ISSUE: Permit to Demolish/Capsulate (partial) and Certificate of Appropriateness for alterations

APPLICANT: Tammy Mann, The Campagna Center, Inc.

LOCATION: Old and Historic Alexandria District
418 and 418 A South Washington Street

STAFF RECOMMENDATION

Figure 3: Existing and proposed main building entry

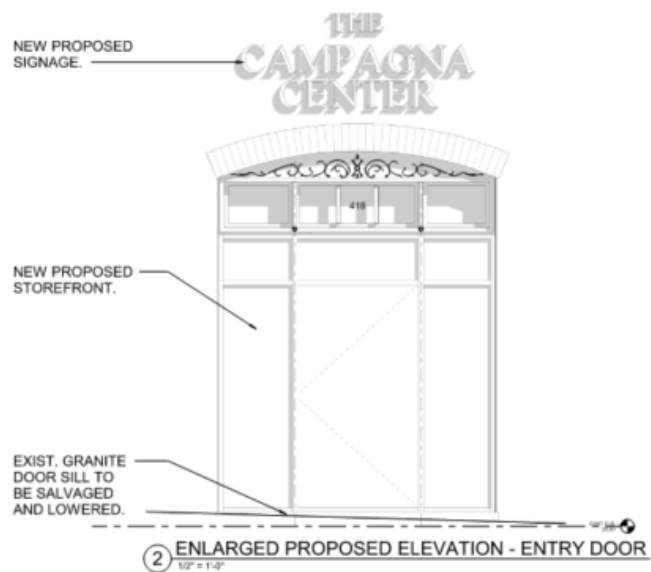
At the main entry door on the South Washington Street elevation of the building, the applicant is proposing to remove the existing entry door, sidelights, steps, and railings. The existing transom, transom framing, and decorative scrollwork above the transom will remain in place. A new storefront style entry door designed to align with the historic transom is being installed at the sidewalk level and the existing stone sill will be relocated to the sidewalk grade. As noted in the application, this work is being undertaken to allow for an accessible main entrance to the building from South Washington Street. An entrance raised above the level of the sidewalk is visible in the early photos however the concrete steps and wood entry doors and sidelights are clearly not original to the building. The applicant is also proposing to replace the existing windows along the ground floor with taller windows by removing the wood sill and a portion of the brick below each window (Figure 2). This is being done to accommodate the lowering of the ground floor level.

Staff supports the proposed work at the main building entrance. The proposed modifications to the main entrance retain the original historic fabric including the masonry opening, the transom, transom framing, decorative scrollwork, and stone sill. The material to be removed is not original and the change in elevation in the current condition presents a barrier to the creation of an accessible entrance to this commercial building. Alternatives to the proposed configuration which would allow for an accessible entrance would include the installation of a ramp which would be more destructive to the historic building than the proposed reconfiguration. This proposal retains the historic fabric of the entrance, while allowing for use of the building by the public (Figure 3).

Figure 6: Site plan showing proposed patio

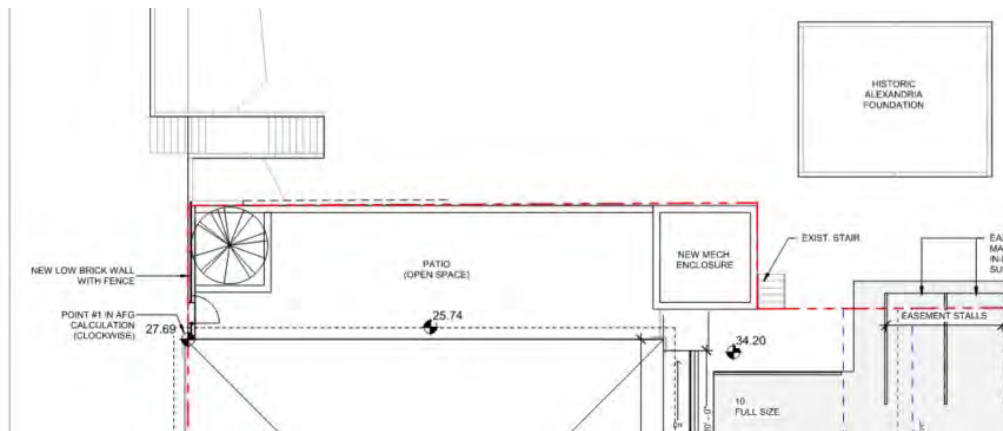
The applicant is proposing to excavate the north end of the site extending to the north property line. This area will be excavated to an elevation similar to the elevation of the ground floor and will be used as an outdoor patio. A planter will be installed at the northwest corner of the patio and a brick enclosure for mechanical equipment will be installed at the northeast corner (Figure 6). A brick and decorative metal site wall with a metal gate will be used to enclose the patio on the west side facing South Washington Street. Per the submitted materials, the design for this wall and gate will be reminiscent of other site walls found within the historic district.

Figure 7: Proposed north elevation

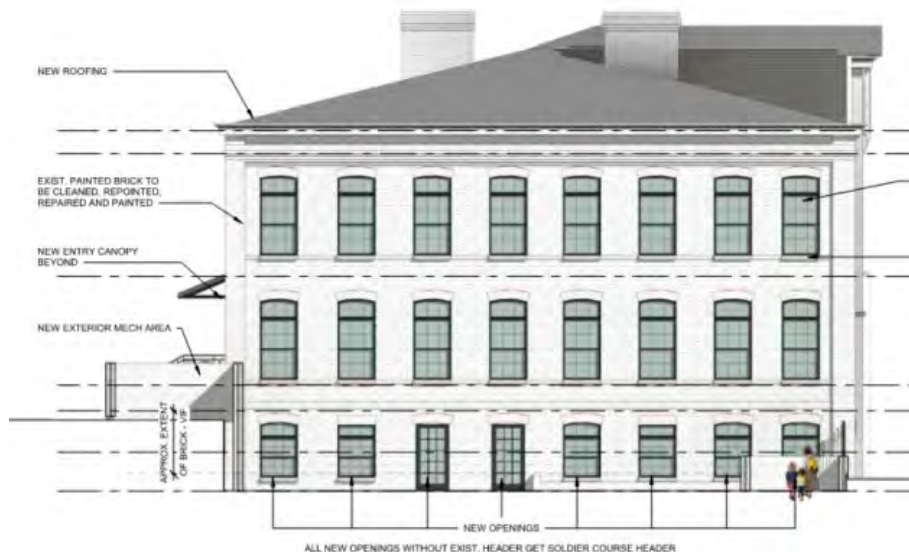
Once the area has been excavated, the ground floor elevation will be modified to open window openings that were closed when the existing berm was built in this area. In addition to opening these windows, two of the previous windows will be converted into doors providing access to the patio and three new window openings will be created. The existing wall openings feature an arched brick head, to differentiate the new openings, they will use a simple soldier course at the head (Figure 7).

Staff supports the proposed modifications to the north end of the site and to the ground floor of the north elevation and appreciates the efforts of the applicant to restore the original site condition and north elevation. As much of the ground floor of this elevation is obscured by the existing berm and exterior egress stair, the proposed modifications to the elevation do not represent the loss of historic context. The new window openings and enlargement of previous windows into doors fits nicely within the overall pattern of the building and appears much the same as the rhythm of the west elevation. The use of a simple soldier course at the head of the new openings is a subtle but effective way to signal that these are not original openings to future observers. The proposed brick and metal wall and gate are similar to site features found throughout the district and will blend into the historic fabric (Figure 9).
